The Badge Tag-V2 device cannot charge the battery pack (see below):

**A. Diagram of battery pack.**

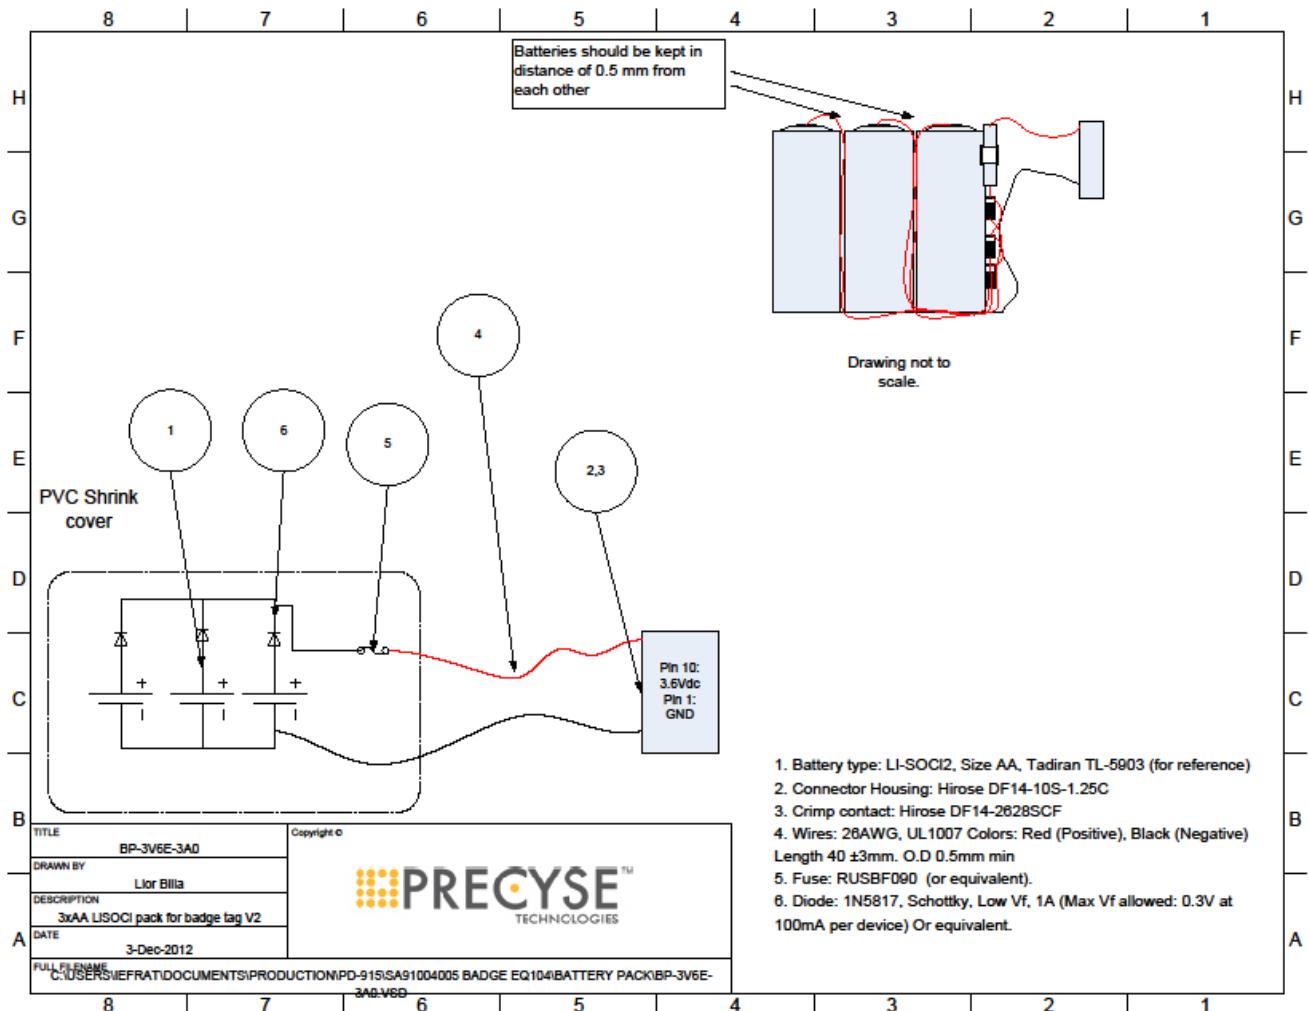
The diodes set the current direction only towards unit.
